[Docket No. FAA–2015–7527; Directorate Identifier 2015–NM–094–AD; Amendment 39–18686; AD 2016–21–05]

Airworthiness Directives; The Boeing Company Airplanes

ACTION: Final rule.

Figure 1 to paragraph (h) of this AD: Wiring Installation - Right Engine Fuel Spar Valve

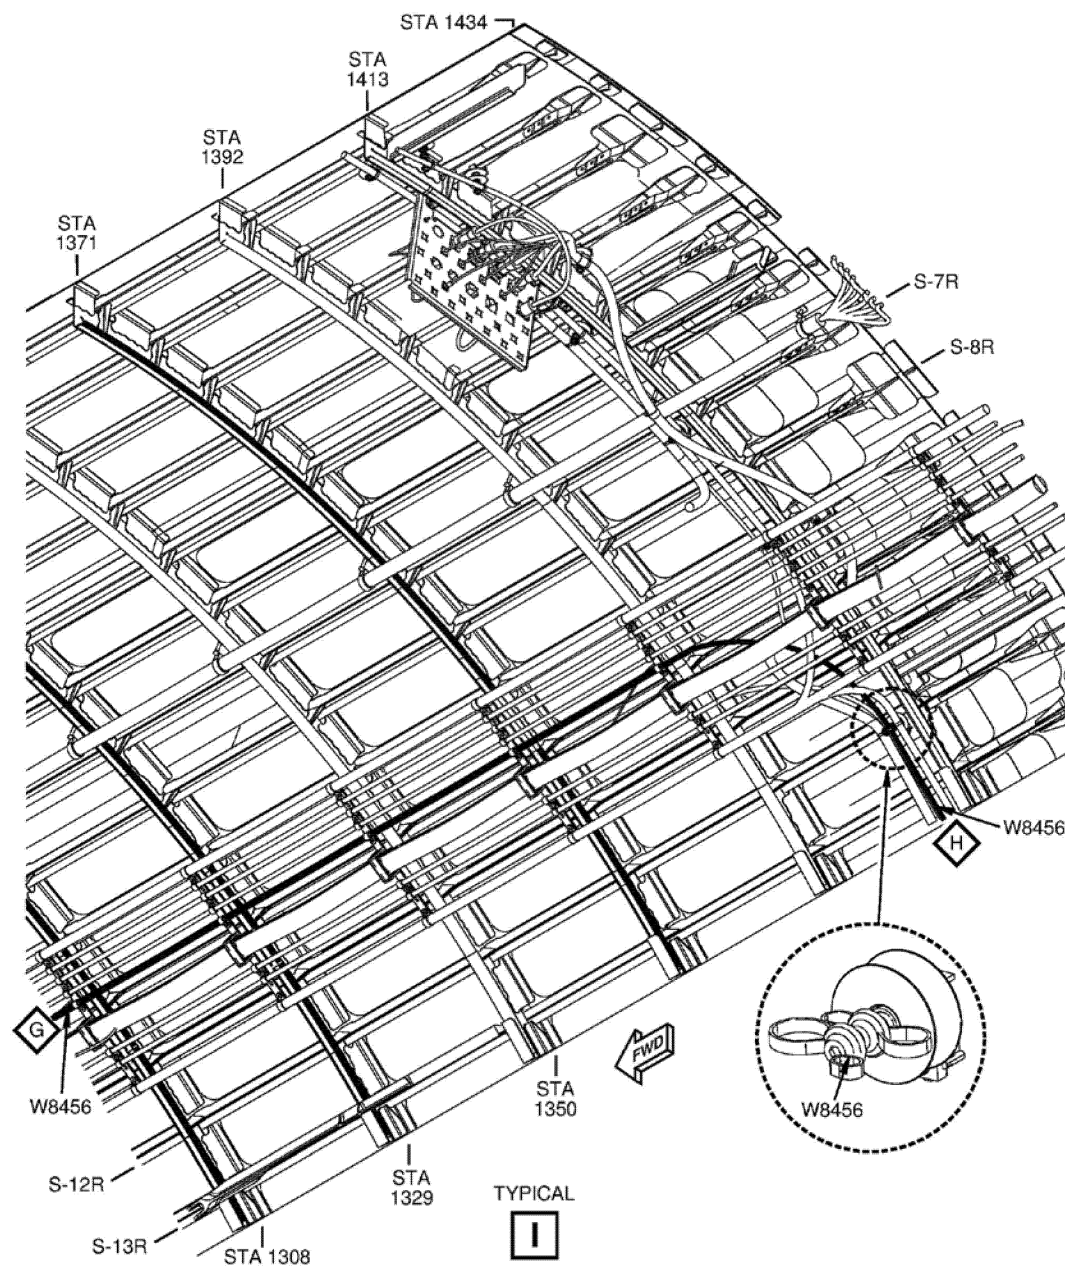
ANA requested that we include Boeing Service Bulletin Information Notice 777–28–0061, IN 03, dated November 16, 2015, to this AD to allow the operators to complete the proposed requirements of the NPRM.

appropriate source of service information in this AD because it is not an FAA-approved document. However, we acknowledge that for certain airplanes, Figure 22, Sheet 9, of Boeing Special Attention Service Bulletin 777–28–0061, Revision 2, dated May 4, 2015, includes an editorial error, which shows incorrect wire routing. Boeing Service Bulletin Information Notice 777–28–0061, IN 03, dated November 16, 2015, allows for a modification of Group 2 airplanes that meets the requirements of the AD without an additional burden to operators. We have included a corrected figure in paragraph (h) of this AD to address this issue.

(1) Where Boeing Special Attention Service Bulletin 777–28–0061, Revision 2, dated May 4, 2015, specifies to use Figure 22, Sheet 9, for the wiring installation of the right engine fuel spar valve, this AD requires using figure 1 to paragraph (h) of this AD.

We partially agree with the commenter’s request. We cannot include Boeing Service Bulletin Information Notice 777–28–0061, IN 03, dated November 16, 2015, as an
